NATIVE HOSPITAL AT NAIROBI

The enclosed despatch (N^o. 529 of 27 August) from the Office Administering the Government of the East Africa Protectorate, on the subject of a new army hospital in Nairobi will be discussed at the next meeting of the Comm. (on 3rd December).

NEW NATIVE & ASIATIC HOSPITAL.
ADMINISTRATION BLOCK. NAIROBI E.A.P.

P.W.D. NO 2020 (REVISE)
FILE NO. 58.
Scale: 8 feet to an Inch.

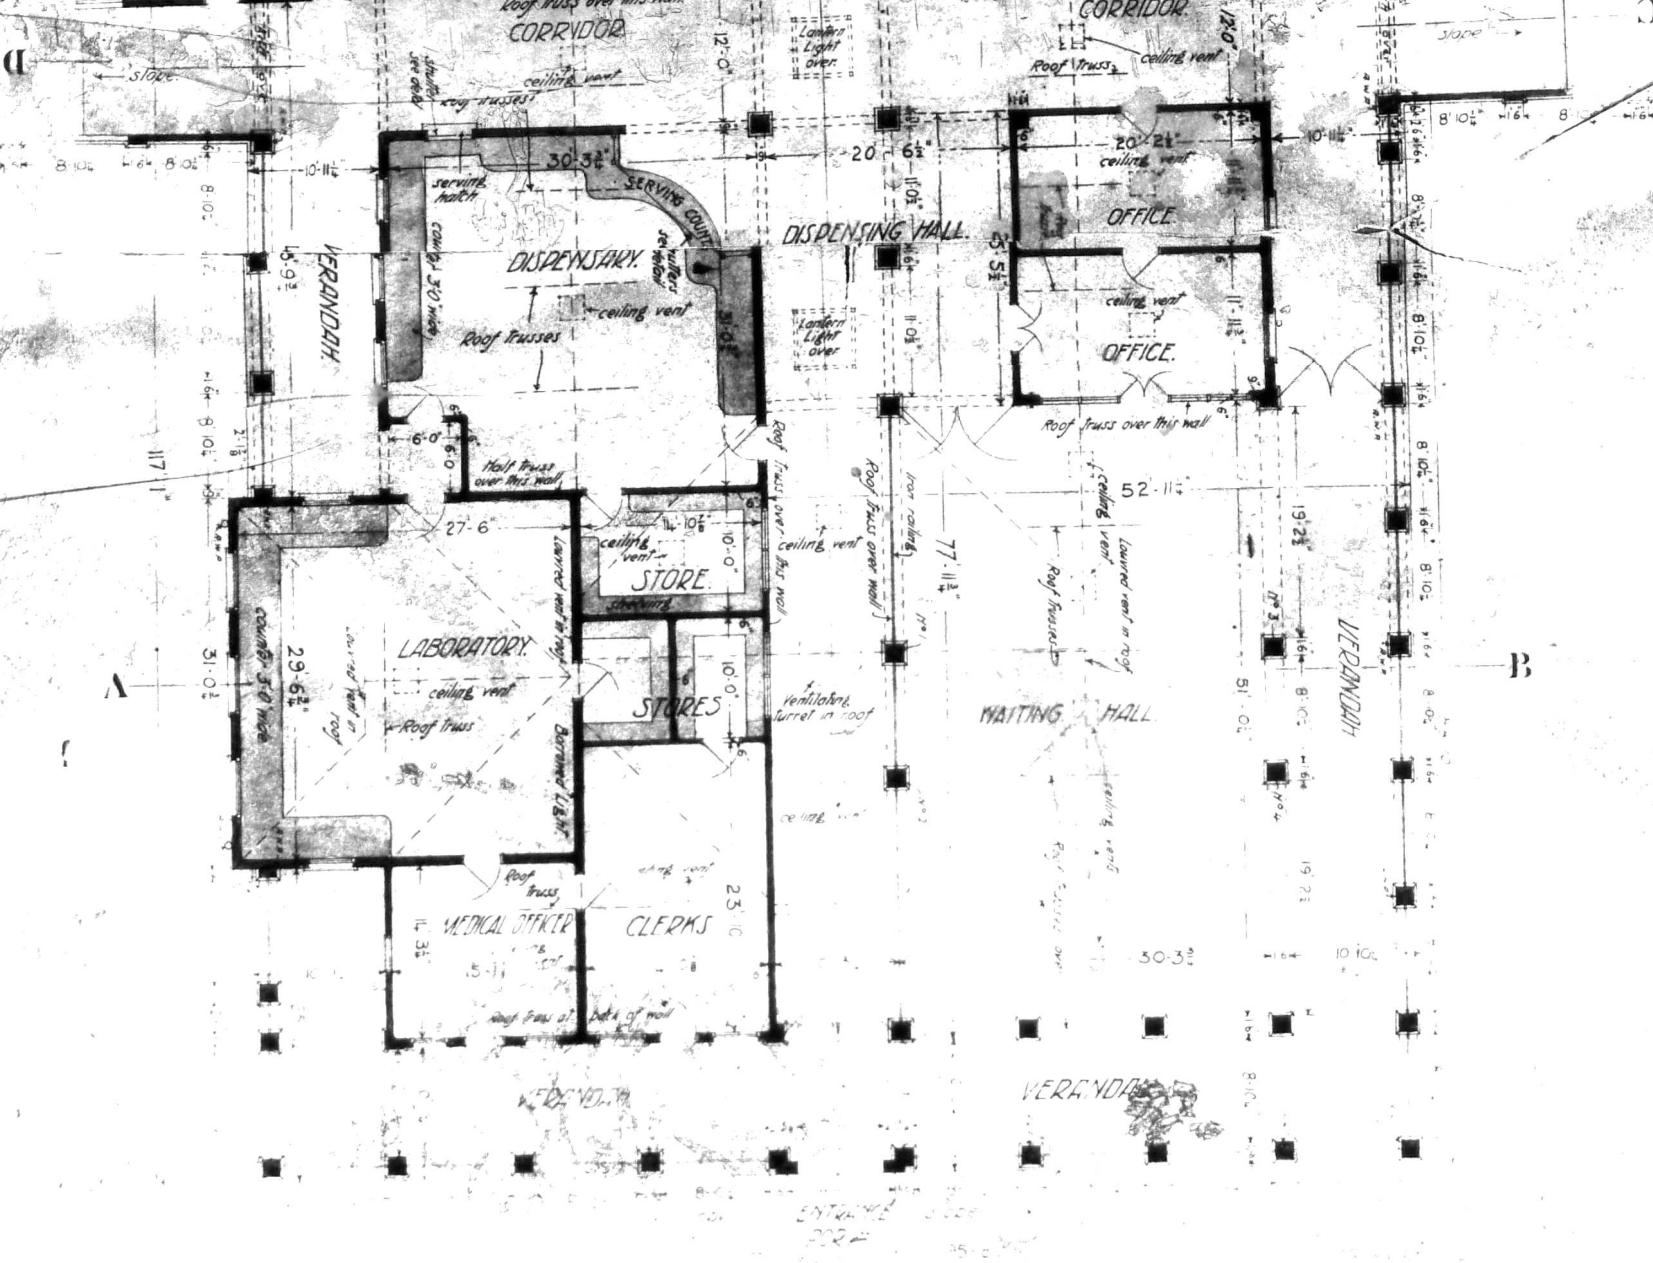
I do not quite follow the plan. There appears to be in contemplation a central Corridor 117 feet in length. Instead of this corridor it would be better to have a central courtyard with verandah and the several administration offices having access to this verandah. Where are the future additions going to be? W. F. Simpson

It would have been
interesting to see
elevation as well
the plan. I hope to
encourage with C.
entitled to it the
other old imports
matter in which
A.

2. Your despatch was referred to the Advisory Medical and Sanitary Committee for Tropical Africa and various comments have been furnished to me by the expert members of the Committee. It has been suggested that instead of the long central corridor, it would be better to have a central court-yard and verandah, and that the several administration offices should have access to this verandah. Attention is drawn to the importance of the verandahs being ventilated and it is suggested that an elevation would have been useful in addition to the plan which accompanied your despatch.

~~of the Committee,~~) that
it would be better if the operating theatre
are directly opposite the corridor so that patients
could be brought straight into the theatre. The
haesthetic and dressing rooms would under this
plan be moved to the left, the sterilising room being
immediately to the right of the operating theatre.
